From: Bartus, Cindy
Sent: Wednesday, August 21, 2024 3:49 PM
To: Frederick, Barbara; Callahan, William; Frank Stroker; mfalcone@preservationpgh.org; Grinnell, David R; Matthew Craig; John Fitzpatrick; thomas.barbush@rrd.com; Jerome Jackson; etobin@pittsburghparks.org; Briley@pittsburghparks.org; sharon.spooner@pittsburghpa.gov; StephanieJoy.Everett@pittsburghpa.gov; Setzler, Eric; michael.panzitta; Ceoffe, Lisa; Gaul, Chip; Feichtner, Erin; Sean Chappell; John Costello; Rick Belloli, Q Development
Cc: Bowen, Kirsten; Pinizzotto, Amy; Zinn, Timothy; Shoemaker, Jeremy R; Cawley, Christopher P.; Anthony, David (PENNDOT); Young, Mark; tkotlensky; michael.kelley@pittsburghpa.gov; chris.hornstein@pittsburghpa.gov; Martinez, Genesis; Rush, Joe; Smith, Kara; Colorito, Aaron; Belfast, Jesse
Subject: FINAL DRAFT - DAT#3 FOLLOW UP AND DESIGN UPDATE: Norfolk Southern - Pittsburgh Vertical Clearance - Design Advisory Team Meeting

All,
As a follow-up to our DAT Meeting #3 held on 3/26/2024, attached are the responses to the comments received (ATT. 1) and the results of the survey sent on 3/28/2024 (ATT. 2). Also attached is the updated design for the W. North Ave. Bridge planters that was devel

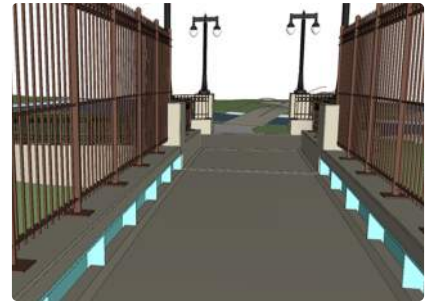
There was discussion at the meeting about including some form of metal panels along the inside of the bridge to minimize trash and leaf collecting locations. This should be done. This provides an opportunity to utilize something other than solid panels as well (<https://www.amazon.com/Outdoor-Privacy-Screen-Metal-Freestanding/dp/B0BWMWR5FL?th=1>). Panels like this could even be railroad or park-themed.

5	Survey AC Pedestrian Bridge	Rick Belloli Q Development	There was discussion at the meeting about including some form of metal panels along the inside of the bridge to minimize trash and leaf collecting locations. This should be done. This provides an opportunity to utilize something other than solid panels as well (https://www.amazon.com/Outdoor-Privacy-Screen-Metal-Freestanding/dp/B0BWMWR5FL?th=1). Panels like this could even be railroad or park-themed.	Solid panels are preferred by the City of Pittsburgh.
6	Survey W. North Ave. Bridge	Jerome Jackson Northside Leadership Conference	It is very difficult to make an informed selection without discussion. I really don't understand how this process is community friendly. When will the community at large get the opportunity to give feedback?	Three Design Advisory Team meetings were held with members of the Design Advisory Team. Two additional Technical meetings were held as a result of comments from the second Design Advisory Meeting.

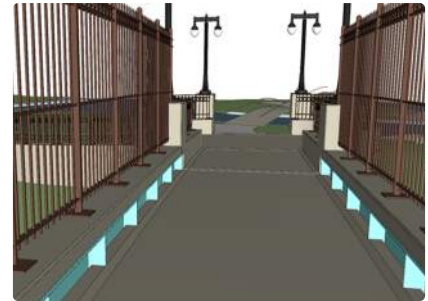
Possible painted panel to cover the exposed stell surfaces.

11	Survey AC Pedestrian Bridge and 4/3/2024 Email	Frank Stroker Pittsburgh History & Landmarks Foundation	Possible painted panel to cover the exposed steel surfaces. We request the exposed steel along the pedestrian path of the bridge to be enclosed with a secure panel that may be removed for inspection purposes. The color should match the painted concrete.	Noted.
12	4/3/2024 Email - AC Pedestrian Bridge	Frank Stroker Pittsburgh History & Landmarks Foundation	We prefer the geosynthetic reinforced soil option for the retaining walls required along the accessible pathways. We would request that a grass or appropriate ground cover be seeded making it consistent with the remainder of the rising grade. We feel that this will not introduce a new structural element and be more harmonious with the existing gentle mounding.	The City has strong reservations about the geosynthetic reinforced soil option – look does not keep with the historical character and maintenance concerns.

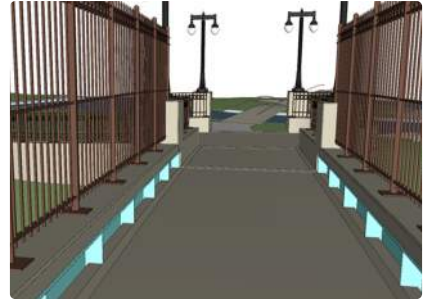
Perhaps integral coloring would be better than painted concrete.

Comment #	Document/Page #/ Section/Paragraph	Commenter	Comments	Responses
		City of Pittsburgh, Department of City Planning		
19	Survey AC Pedestrian Bridge	Mike Panzitta City of Pittsburgh DOMI (and nearby resident)	Perhaps integral coloring would be better than painted concrete.	Integral coloring was considered, however due to the different types of concrete the coloring would not be consistent when constructed and even less consistent for any future maintenance, therefore we selected the painted concrete to match West Ohio Street.
20	Survey W. North Ave. Bridge	Barbara Frederick PA SHPO	No additional comments.	Noted.
21	Survey AC Pedestrian Bridge	Barbara Frederick PA SHPO	No additional comments.	Noted.
22	4/4/2024 Email	Eric Setzler City of Pittsburgh DOMI	It is anticipated that the diagonal sidewalk on the southeast corner will be a popular place to stop and look at trains and the park. Maintain this width at 7'.	Noted.

NORTH AVENUE PLAN

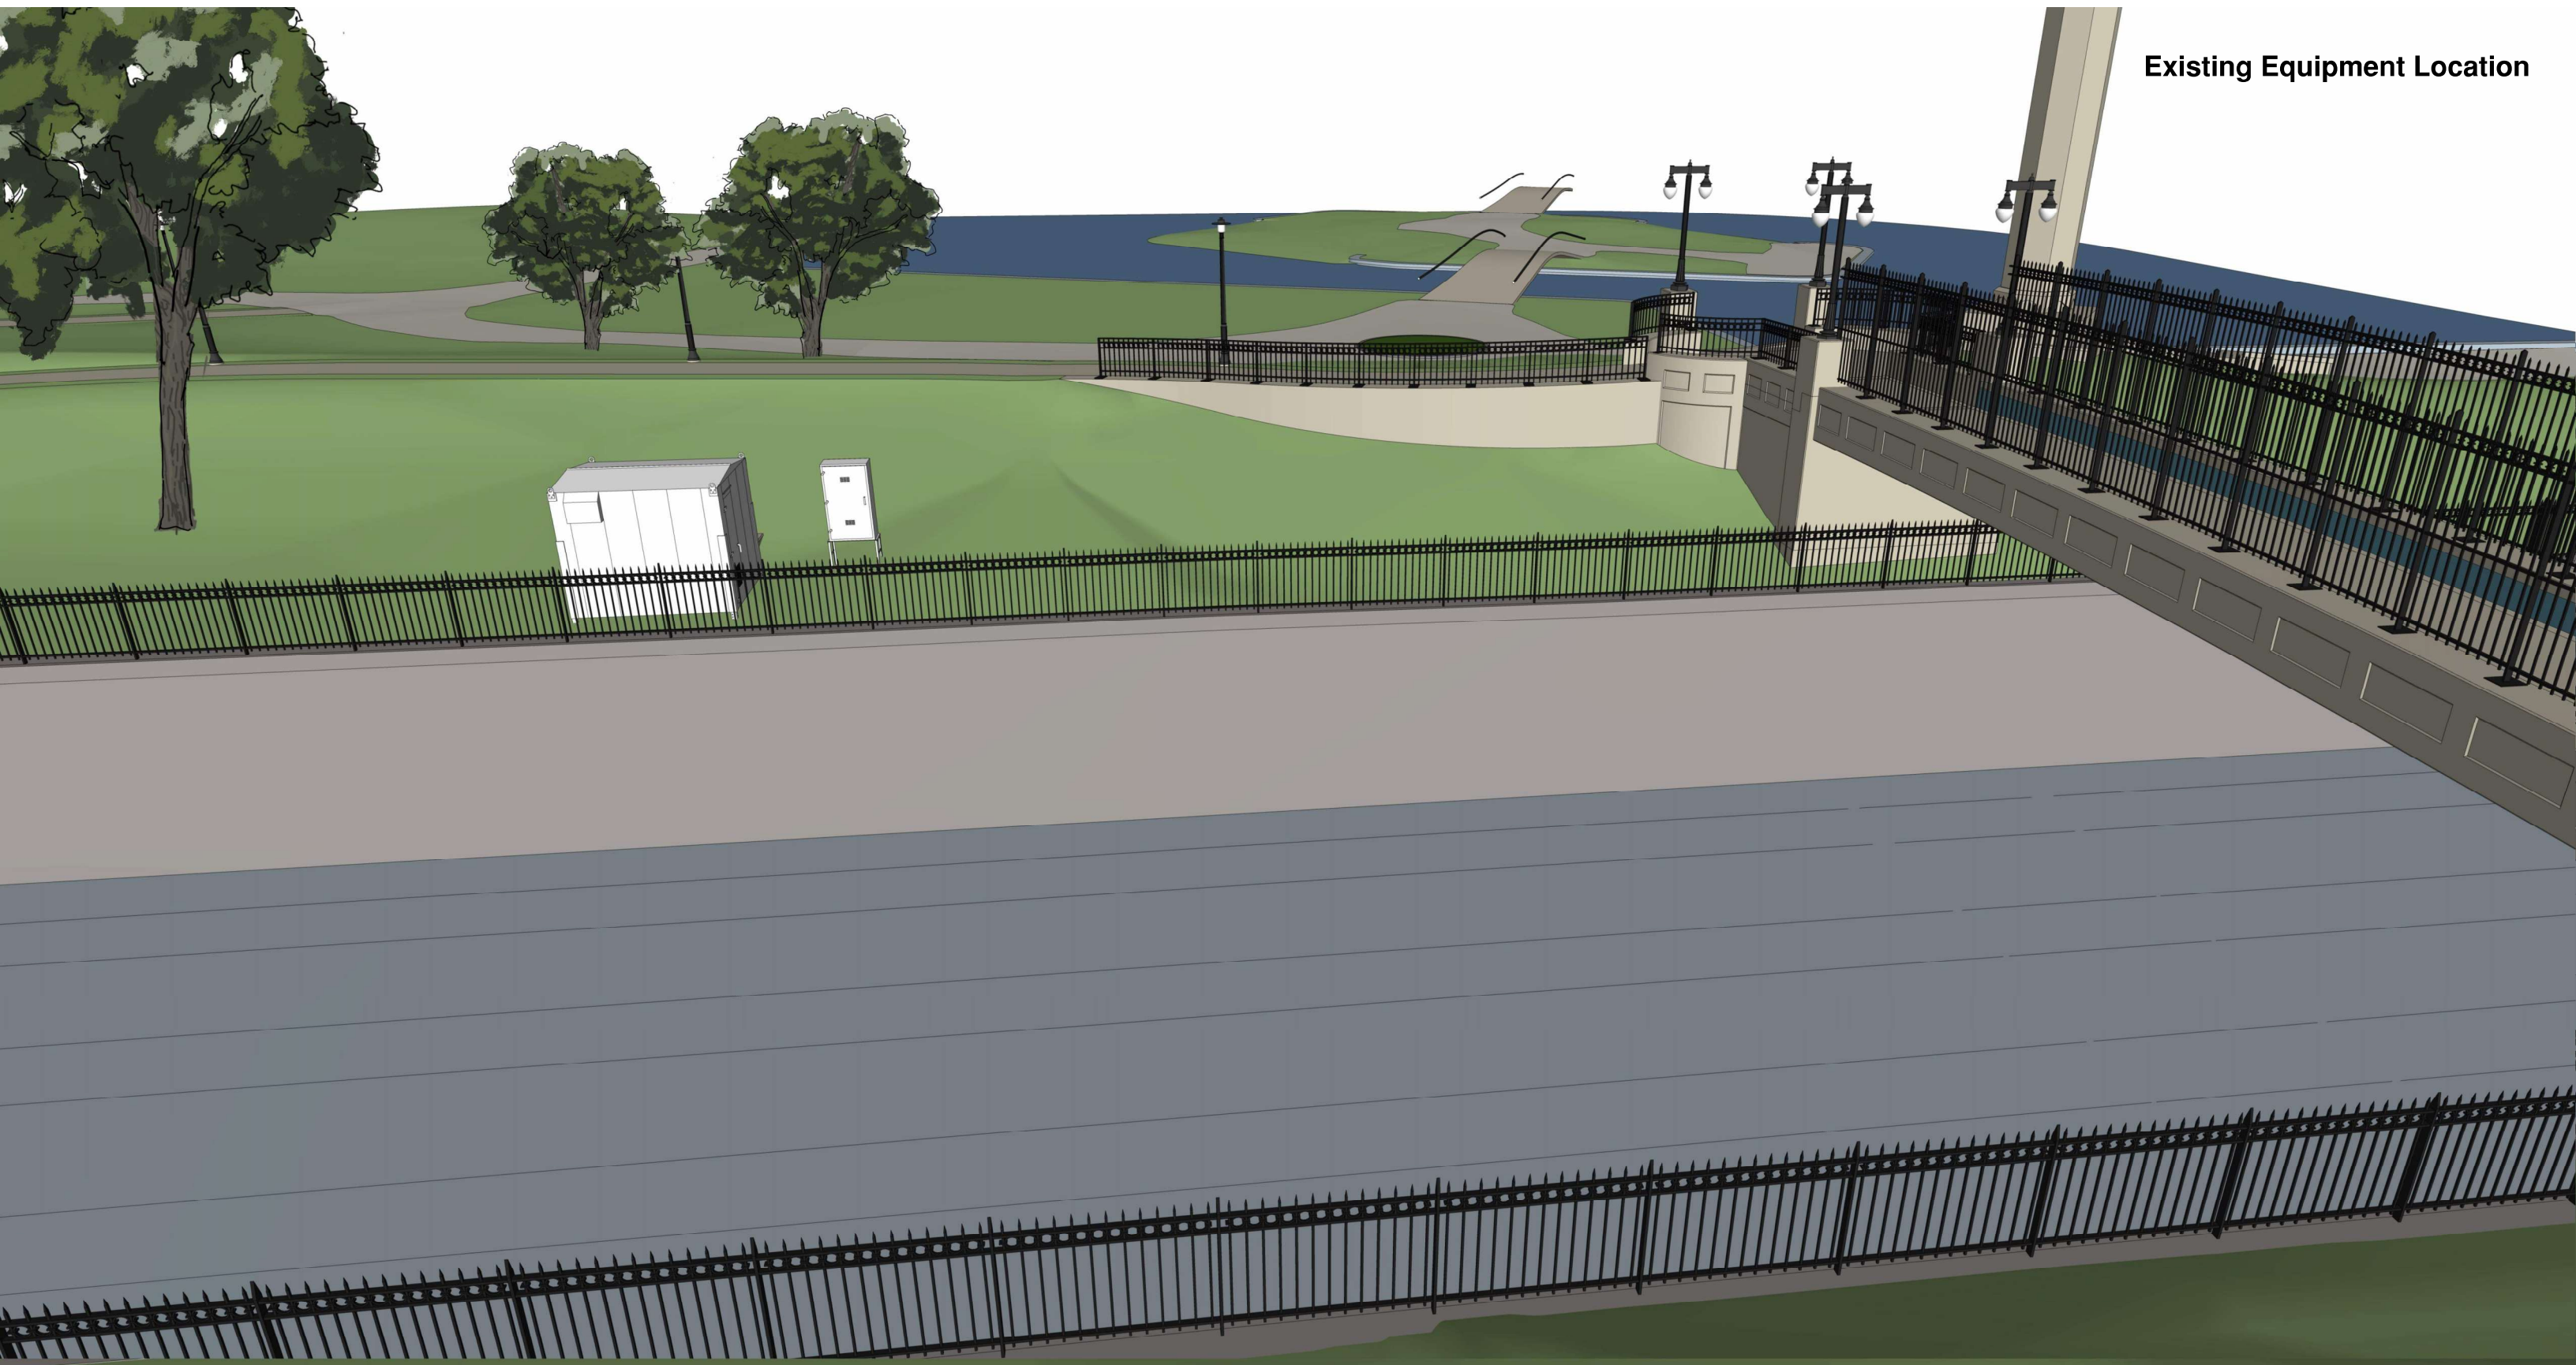
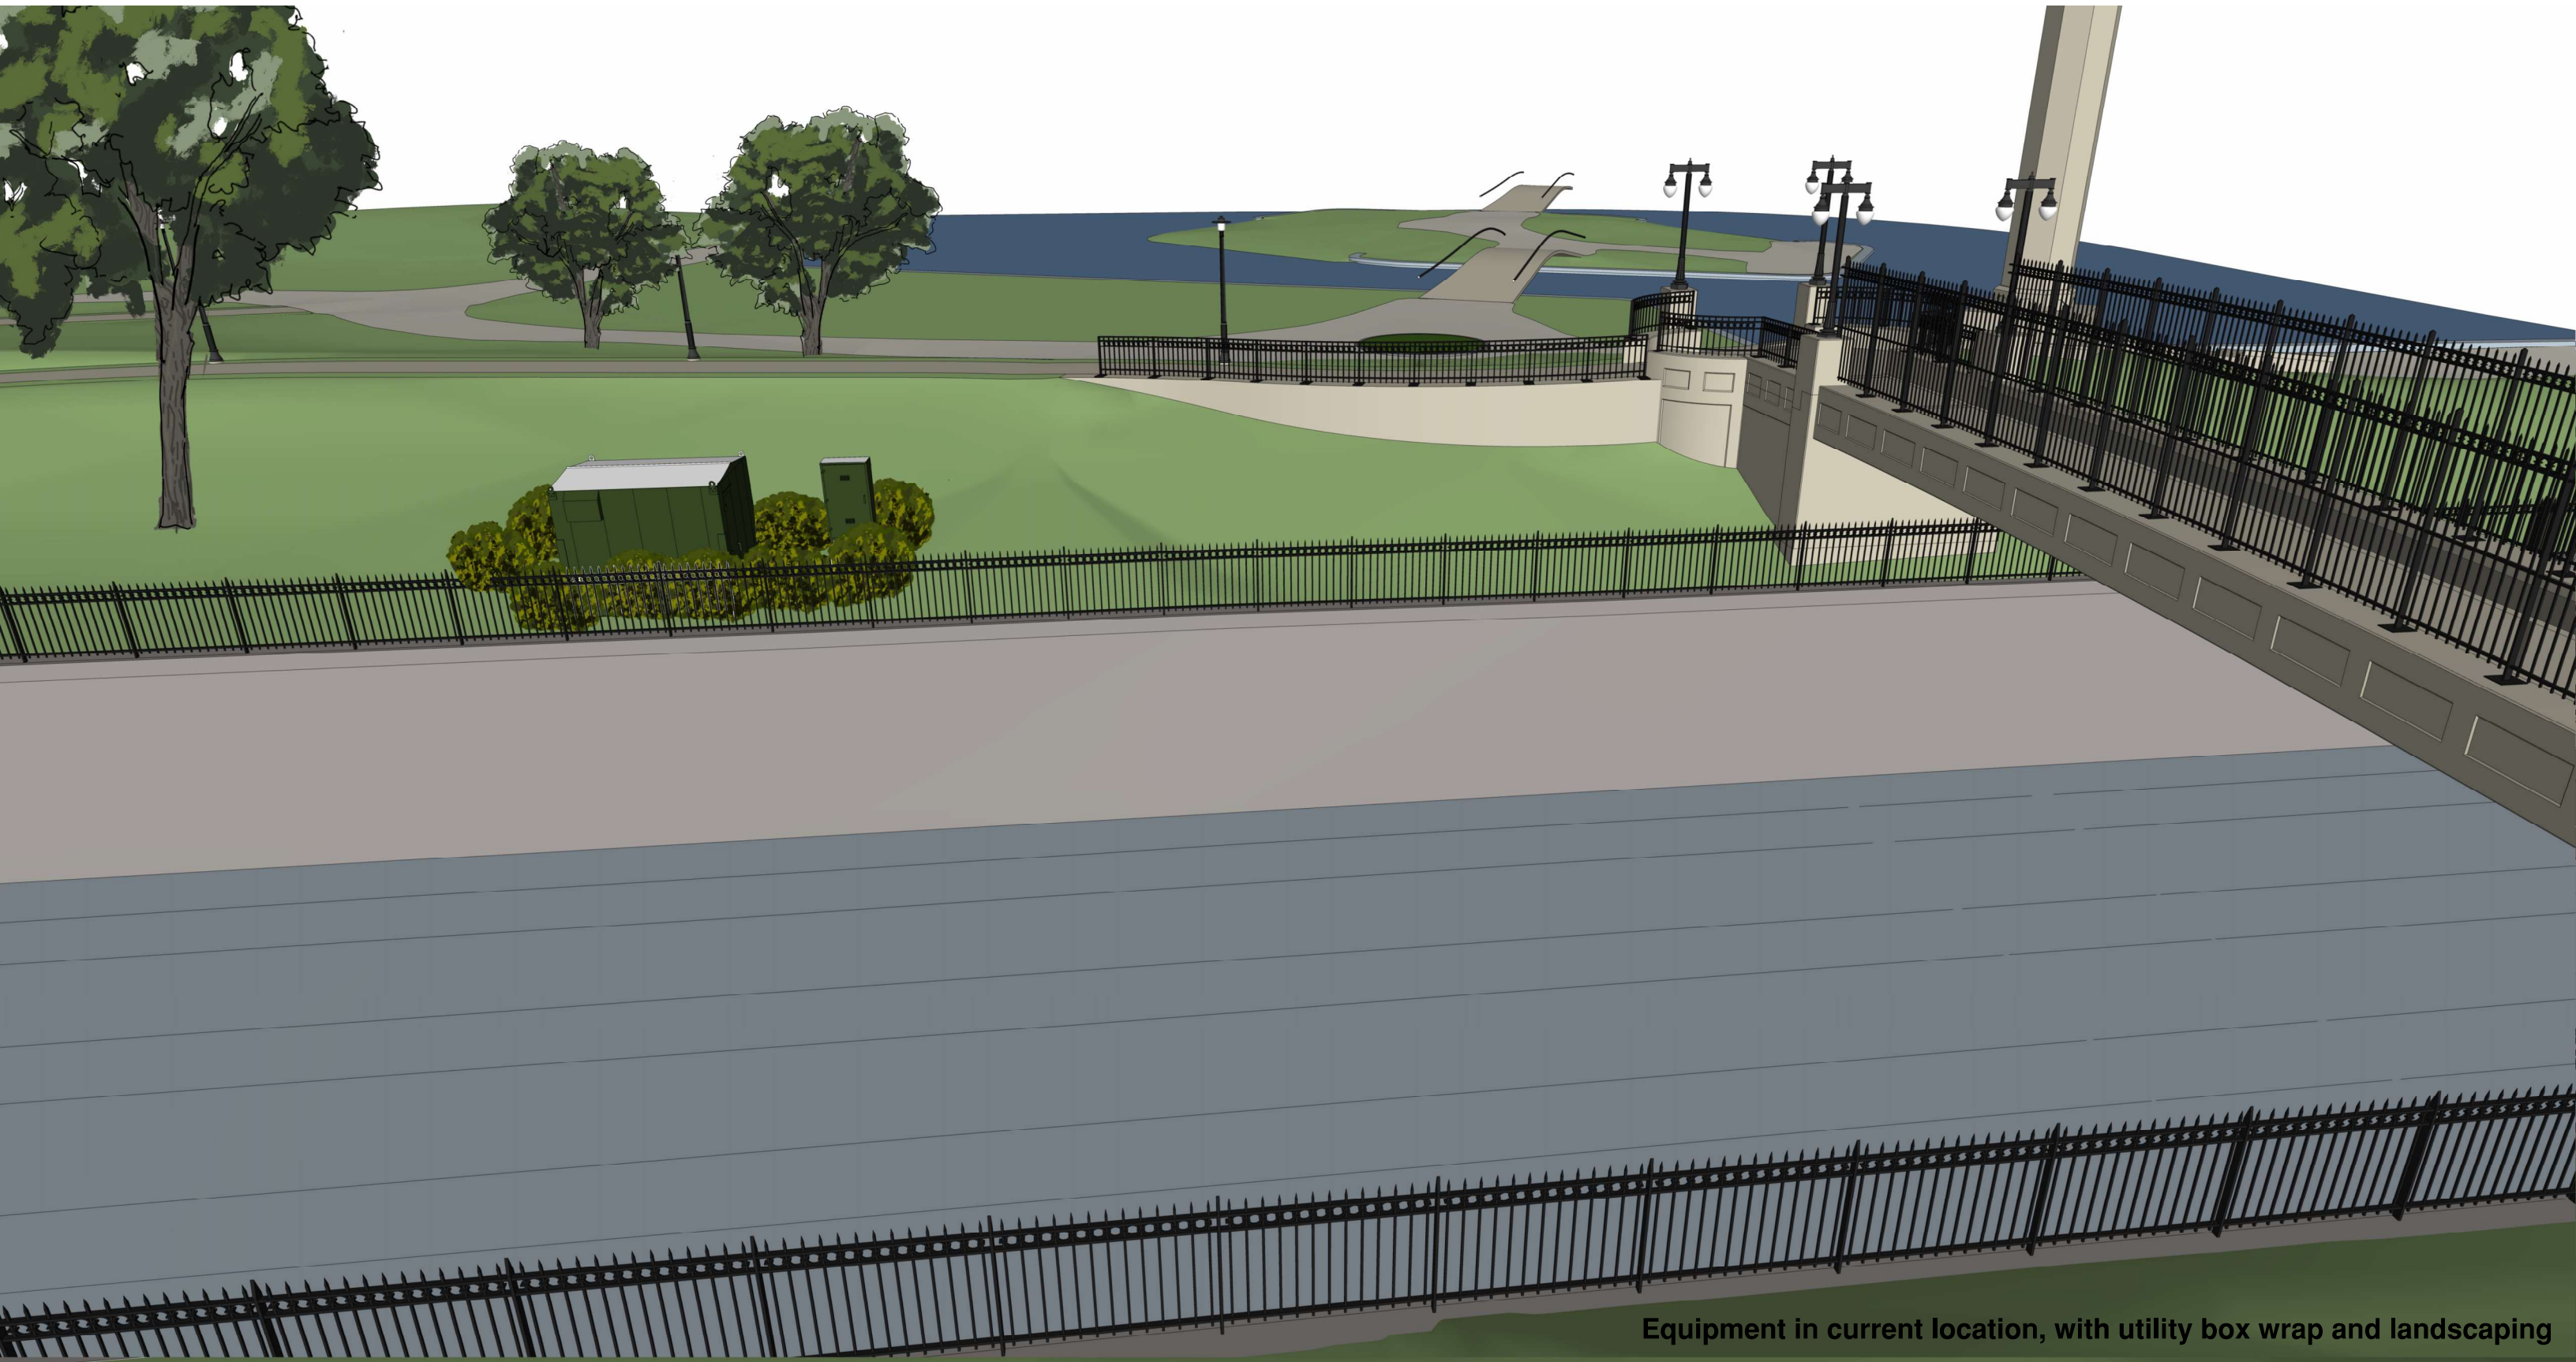
3	4/3/2024 Email W. North Ave. Bridge	Rick Belloli Q-Development	The MBI drawings showed the diagonal sidewalk on the southeast corner to be 7' wide. I thought this could be misleading for a pedestrian heading north on the Brighton Road sidewalk who might think that the wide sidewalk would be a shortcut to the North Avenue sidewalk. So my drawing, once again, shows it 3' wide.	As discussed at the meeting the 3' aiseways are not acceptable to the City of Pittsburgh (DOMI). All interior aiseways will be 4' and the exterior paths along the bridge railing will be 7' wide as per a subsequent comment from the City of Pittsburgh (see comment 22). See attached exhibit.
4	4/3/2024 Email W. North Ave. Bridge	Rick Belloli Q-Development	The MBI drawings showed a quarter circle of sidewalk at the northwest corner to make room for utility poles. My drawing shows the quarter circle passing through the corner of the adjacent planter.	As originally detailed, the existing arc of the northwest off-bridge planter never intersects the nearest on-bridge planter. The radius of the arc can't be changed at this point because it impacts mast arm #5 foundation and associated conduit. Proposed temporary shoring also passes through this area which is needed to construct the Wing C retaining wall, so we can't move the mast arm any farther away from the intersection than it is now. Moving the other way will impact the ADA ramps and potentially the bridge joint at abutment 2.
